LINCOLN COUNTY HEALTH DEPARTMENT
ENVIRONMENTAL HEALTH
AFFIDAVIT OF WASTEWATER TREATMENT AND DISPOSAL SYSTEM COMPLIANCE REVIEW FOR SYSTEM INSTALLED, REPAIRED OR REPLACED WITHOUT A VALID PERMIT

Address or Location: 38 Aero Village Way, Eureka, MT 59917

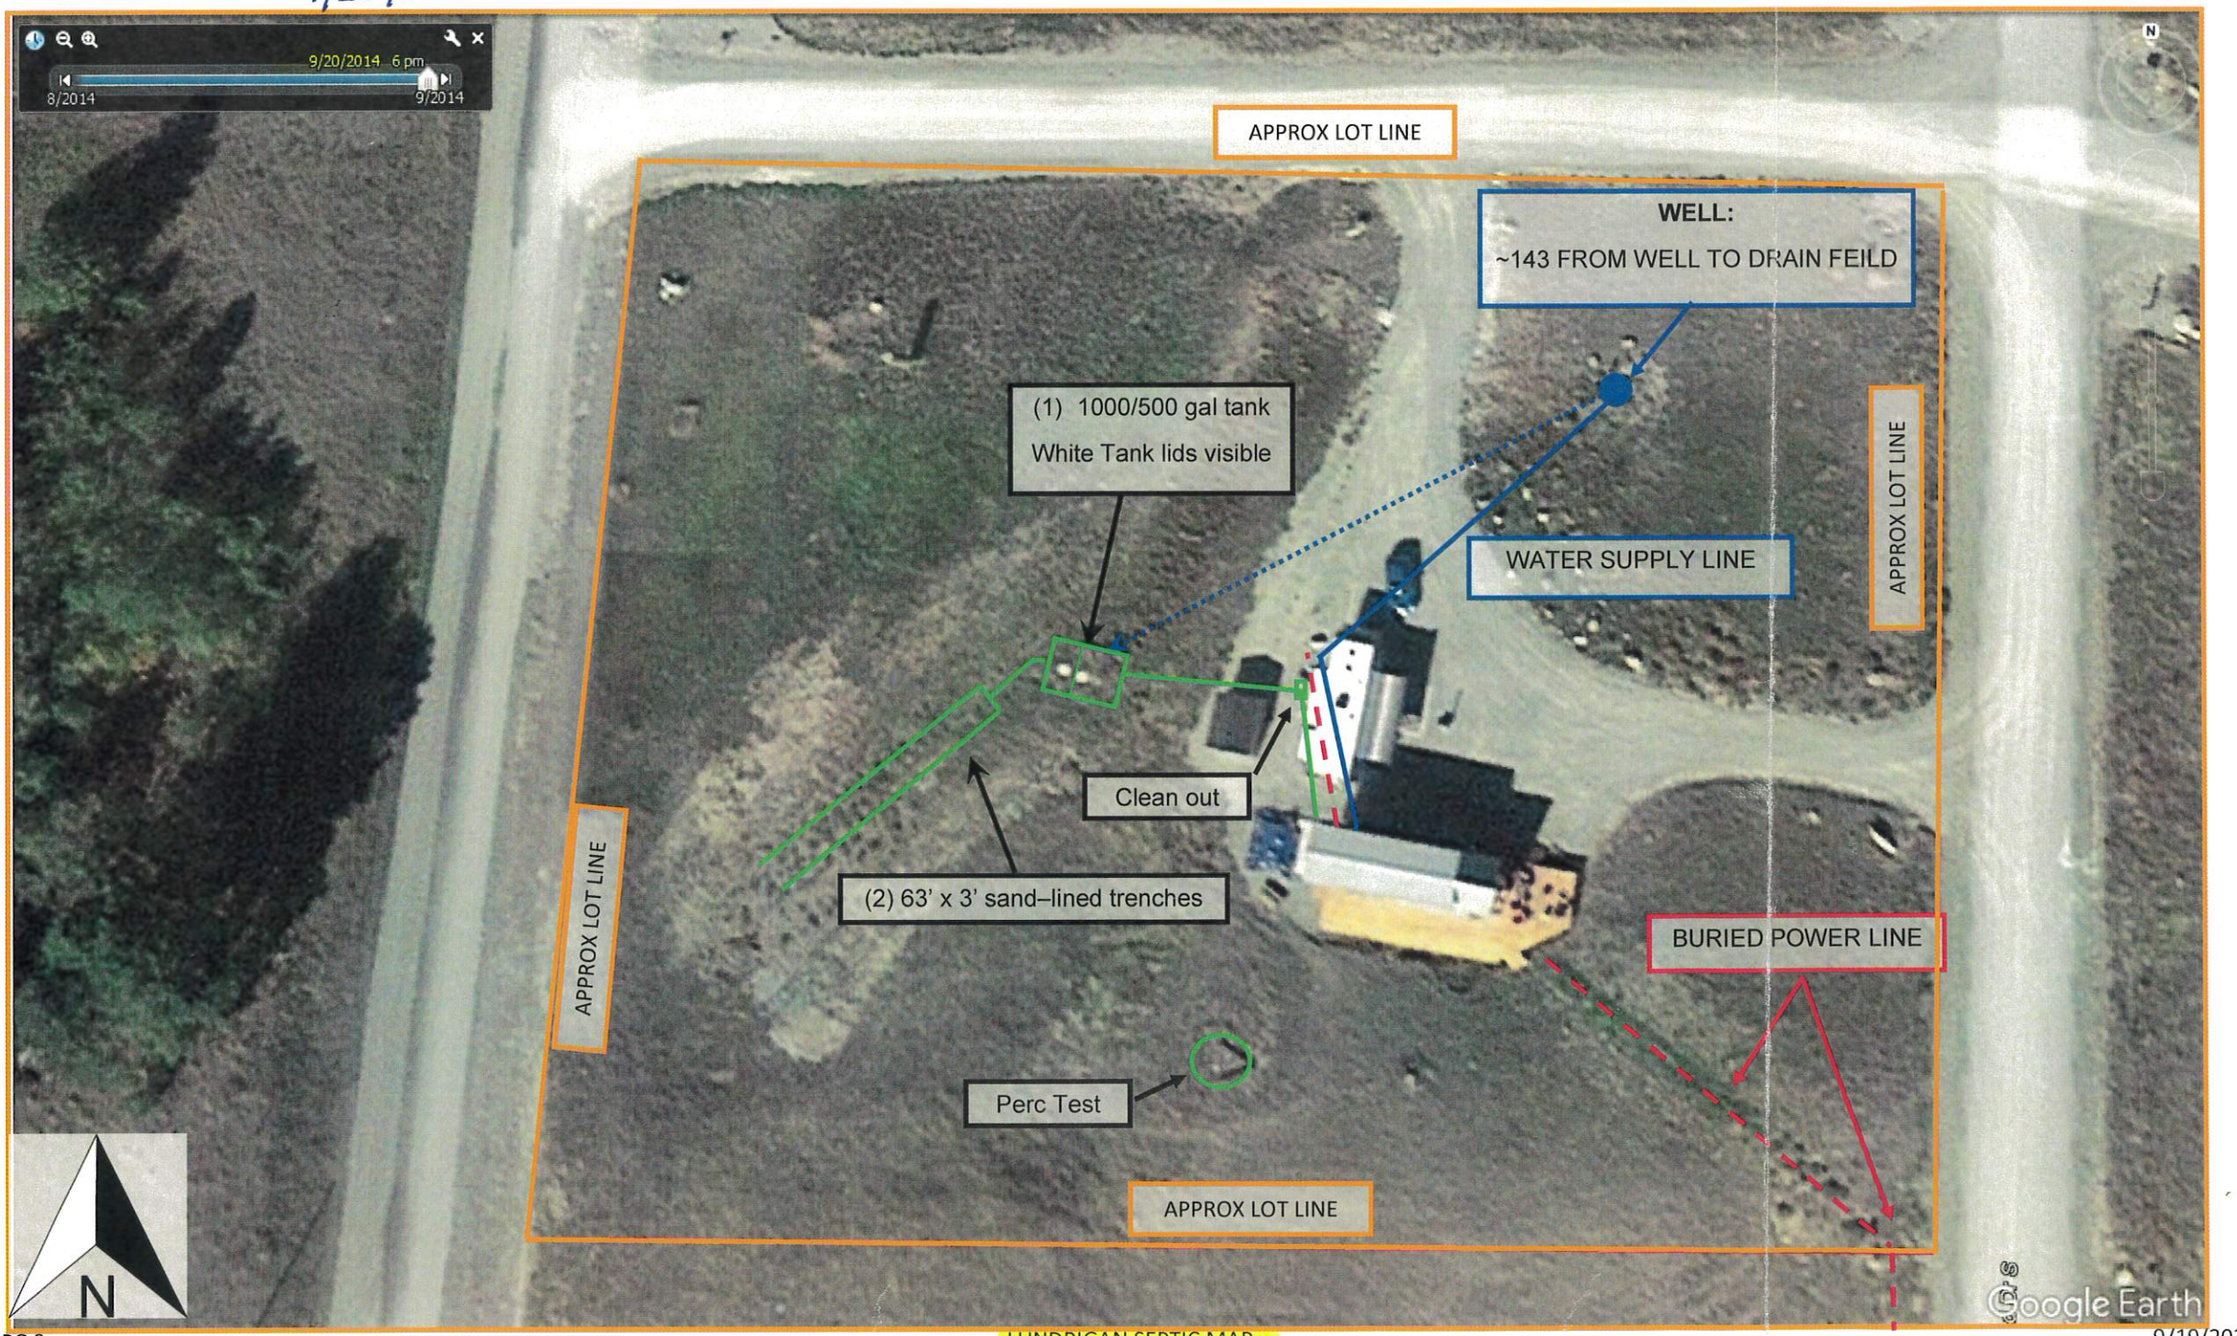
Comments: Pressure dosed system using 1000/500 gallon tank and 3' wide trenches. Two laterals are 63' long with chambers and sand lined. Septic tank was pumped on 9/8/2023 and in good condition. System is appropriately sized for wastewater flows of 300 gallons per day. Any future extension, repair, replacement or increase in wastewater flows must be reviewed and permitted by Lincoln County Health Department.
